**MEMORANDUM**

**TO:** Eric Devlin, City of Melrose  
**FROM:** Brittney Ferber, PE, CFM, Nitsch Engineering  
 Birendra Gurung, PE, PTOE, ENV SP, Nitsch Engineering  
**DATE:** September 19, 2023  
**RE:** Intersection of Melrose Street and Lynn Fells Parkway NOI

Figure 1- Areas Reviewed for Green Infrastructure

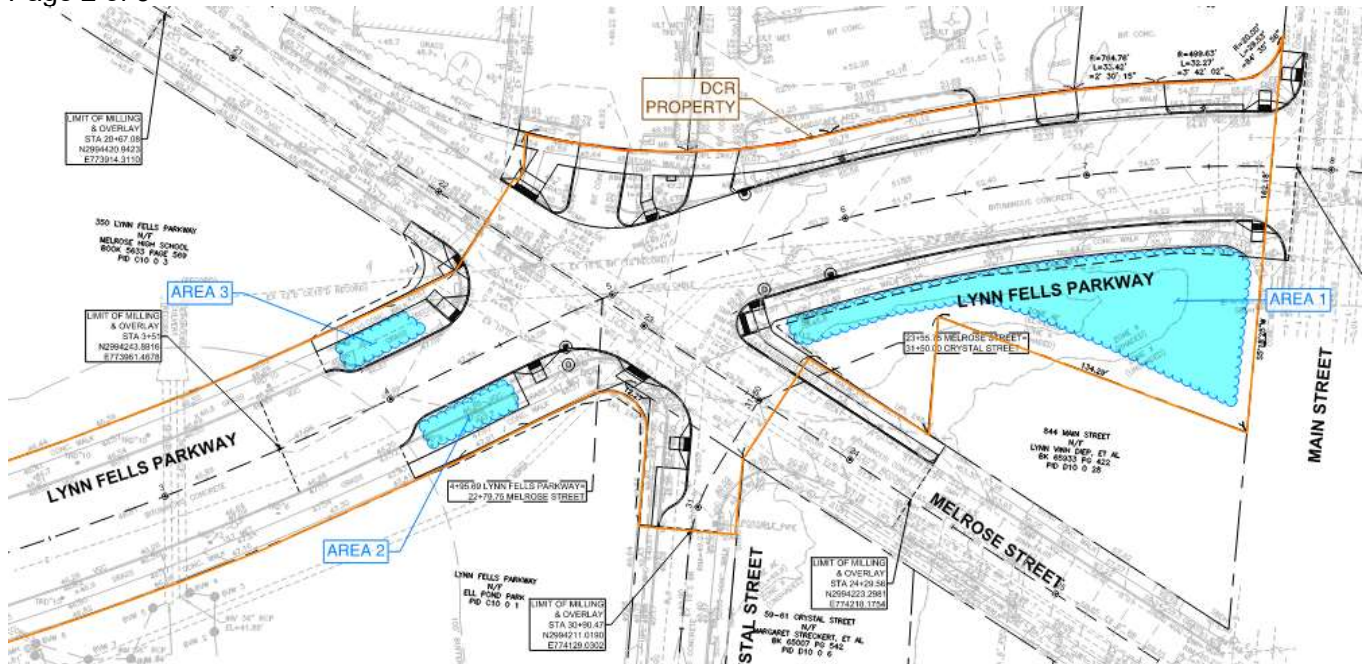
Nitsch Engineering evaluated the project site for the opportunity to construct green infrastructure in the adjacent landscaped/grass spaces. The design team reviewed areas of the site that were within or directly adjacent to the limit of work and on DCR property. Figure 1- Reviewed Green Infrastructure Locations, below and included as an Attachment to this memo, shows the limits of the DCR owned property and the three main areas that were evaluated for use as green infrastructure.

Nitsch evaluated these three areas for use as a swale, rain garden planter, or bioretention basin.

Area 1 was evaluated for the construction of a swale or bioretention basin. A swale would be a linear feature located along the back of sidewalk in Lynn Fells Parkway and a bioretention basin would be located in the triangular area between Lynn Fells Parkway and Main Street. Both options would require extensive regrading because of the grade change at the back of sidewalk and adjacent landscaped area.

Nitsch Engineering eliminated these options because of the mature trees located in this area. Photographs 1 and 2 below show the mature trees adjacent to the existing/proposed sidewalk. Re-grading and introducing stormwater runoff to these areas could damage the health of the existing trees.

<b>GRADING PLAN</b>		SHEET NO.
SURVEY BY: NITSCH DRAWN BY: KC CHECKED BY: BG APPROVED BY: JM		<b>13</b> 13 OF 33
CONT. P20-3361-D1A	SCALE: 1 IN. = 20 FT. DATE: 4/11/2023

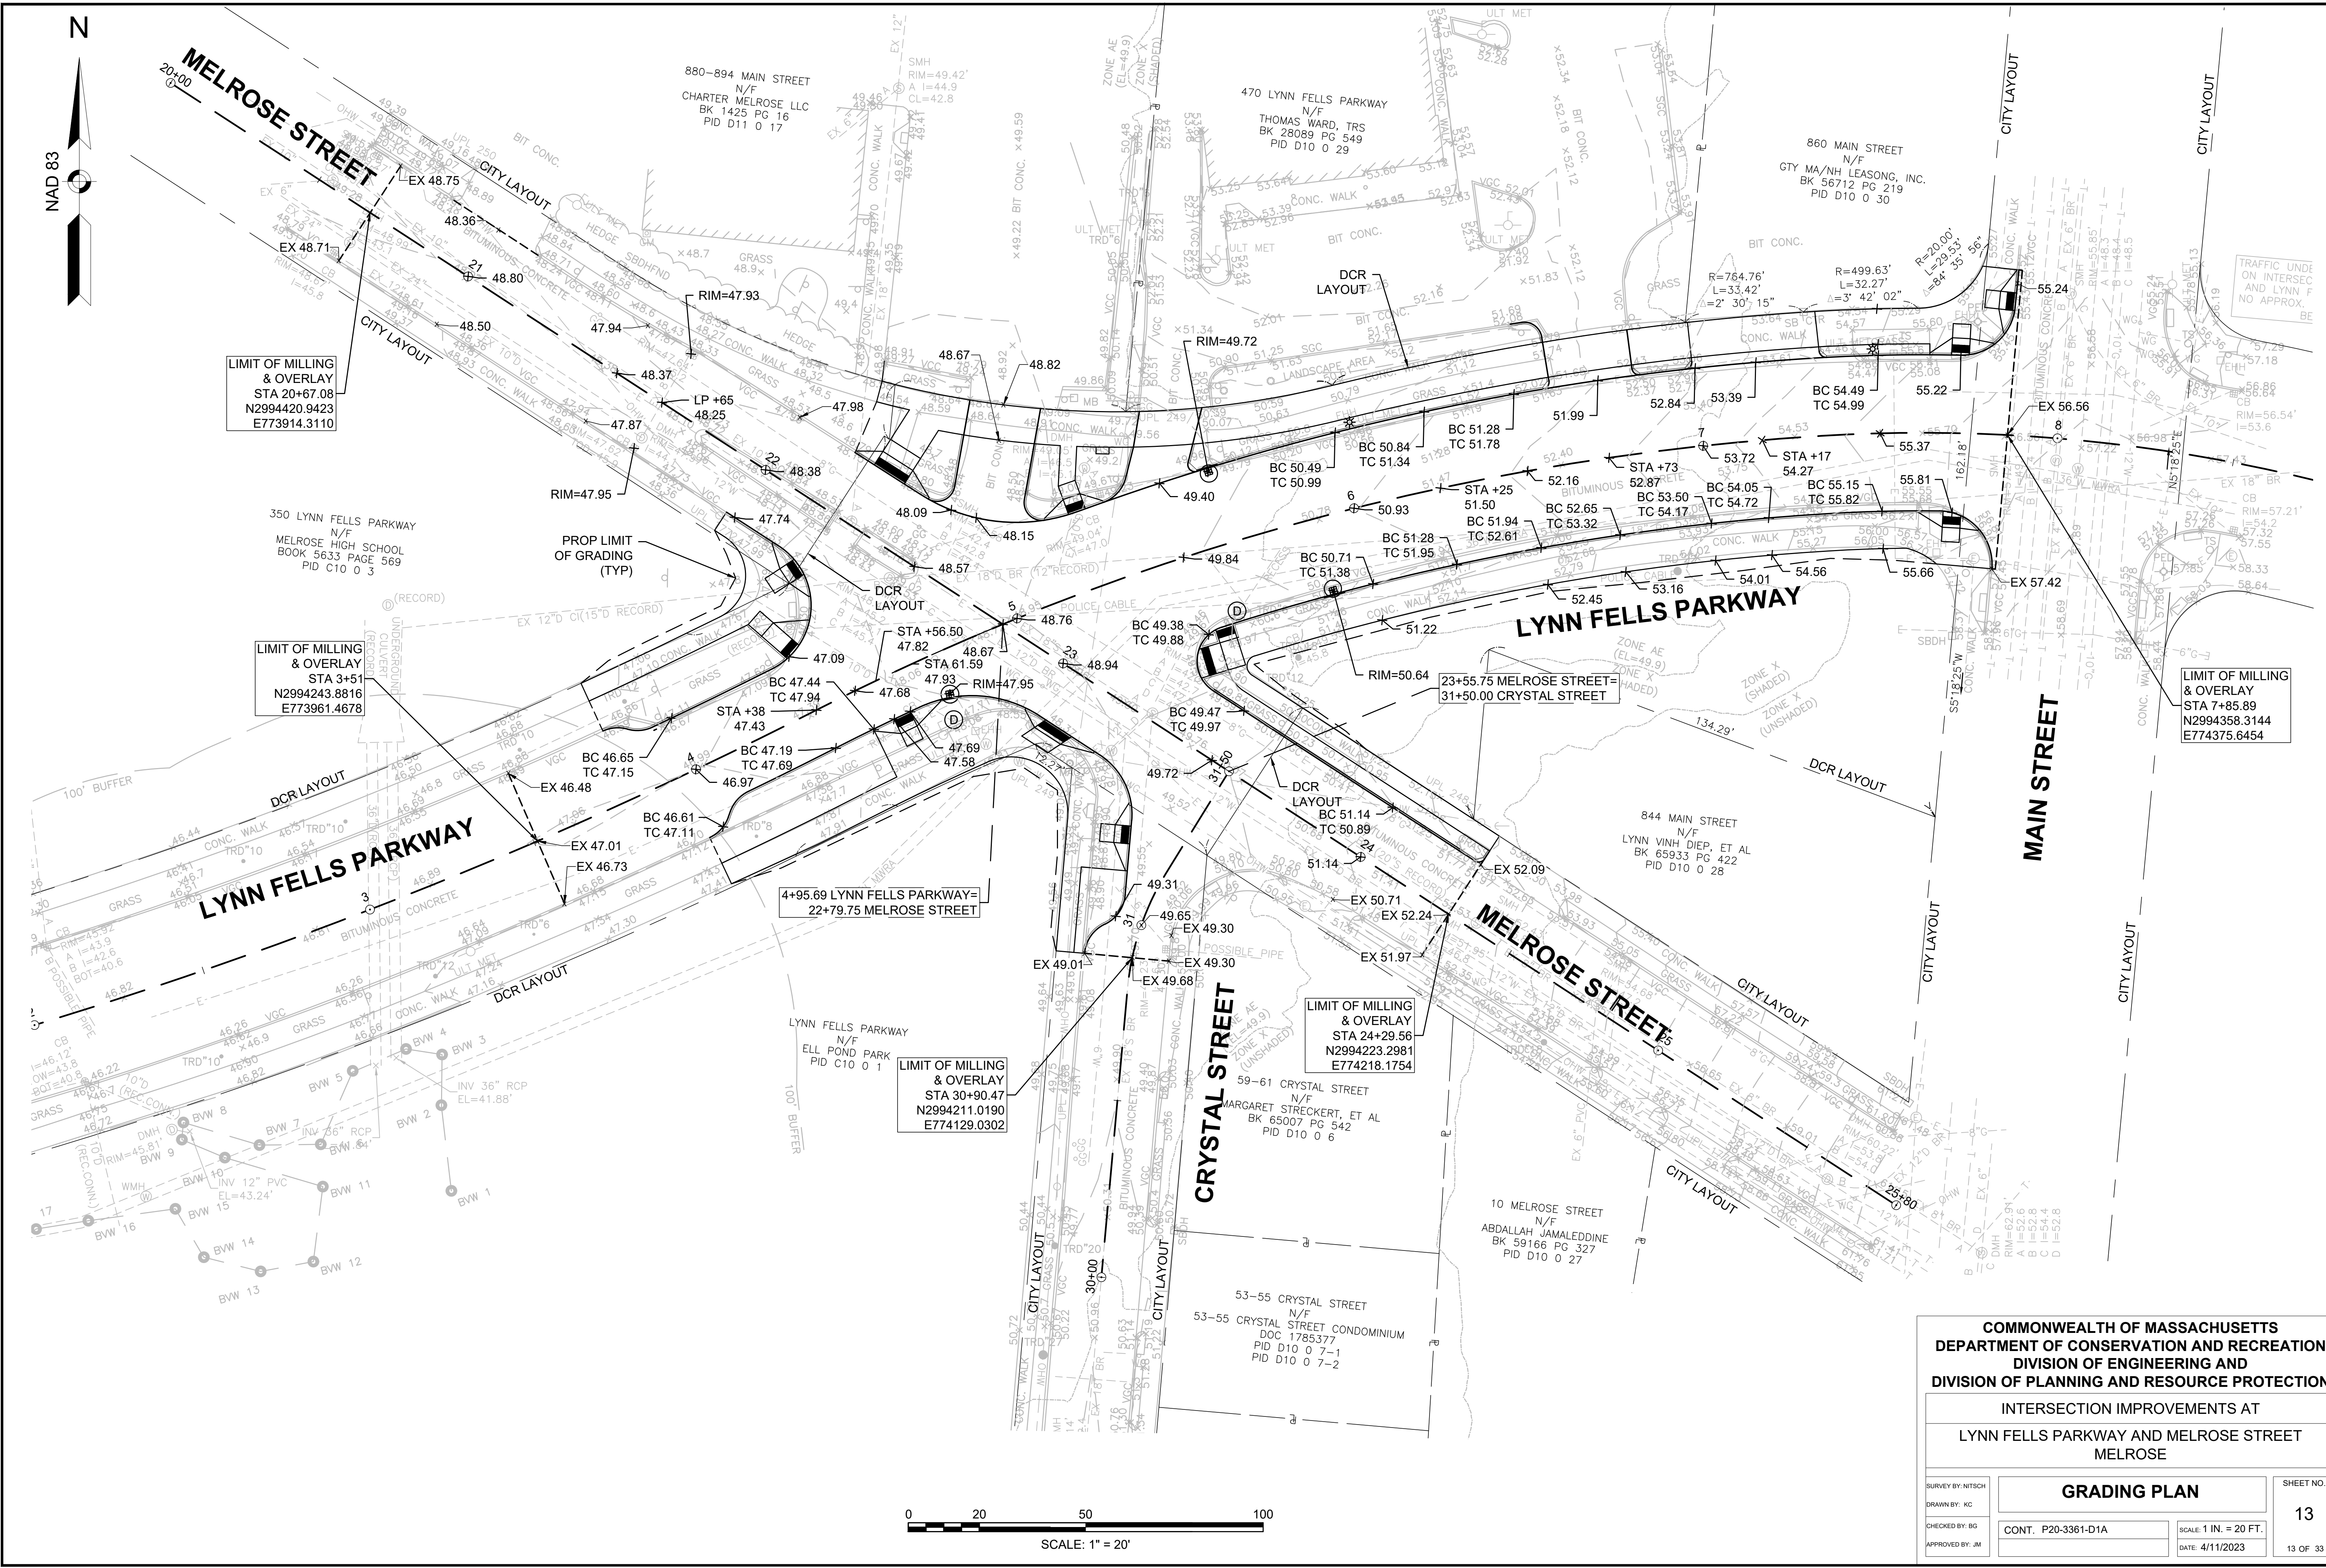
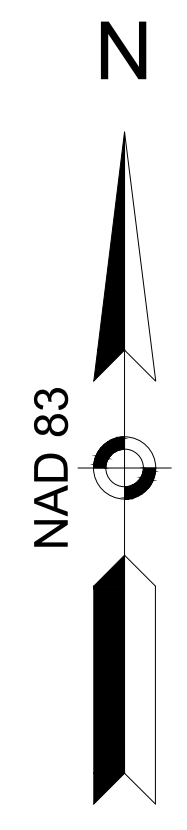
- Confirmation if the existing catch basins have deep sumps;
- A table separating the cut/fill volumes for work in the floodplain by interval rather than as an overall number; and
- A memorandum describing the green infrastructure that was considered for the site.

Table 1 below shows the proposed cut/fill volumes for the proposed site within the Bordering Land Subject to Flooding (BLSF). The grading plan was revised as part of the effort to produce this table and is included as an attachment to this memo.
